## REVISED RESPONSE TO REQUEST FOR ADDITIONAL INFORMATION

### APR1400 Design Certification

Docket No. 52-046

RAI No.: 343-8420  
SRP Section: 12.02 – Radiation Sources  
Application Section: 12.2  
Date of RAI Issue: 12/22/2015

Table 12.3-4 (4 of 7)

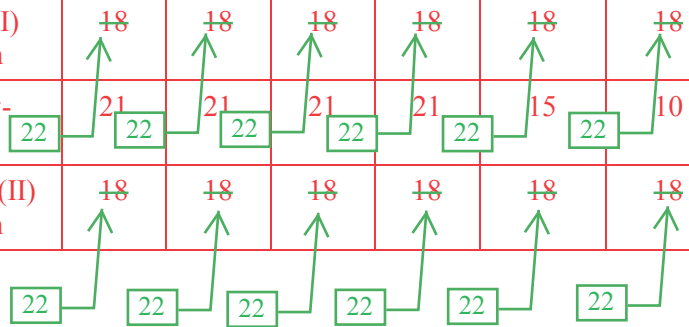
2. SRP 12.2 indicates that source descriptions should include the methods, models, and assumptions used as the bases for all values provided in SAR Section 12.2. The calculations for determining Auxiliary Building ventilation filter activity were not included as part of the source term audit.

In the response to question 4 of the “Additional Follow up Questions from the August 12, 2015 teleconference” section of the document referenced above (on page 6), the applicant indicates that the Auxiliary Building ventilation filter source term was calculated based on values from the PWR-GALE code which were then back calculated based on the Auxiliary Building flow rate and then adjusted to take into account the shielding design basis source term of 0.25% fuel defect. Since the PWR-GALE code is based on data from nuclear power plant operation with minimal fuel damage and also uses different assumptions than those used in the 0.25% source term calculations of airborne radioactive material, it is unclear to staff how the values of releases from the PWR-GALE code would be converted to the 0.25% fuel defect source term in the ventilation system. Please provide a detailed description and/ or calculations demonstrating the methodology used to convert GALE code results to Auxiliary Building ventilation system values based on 0.25% fuel defect.

DCD Tier 2 Section 12.3, Table 12.3-4 will be revised as indicated in the Attachment 2.
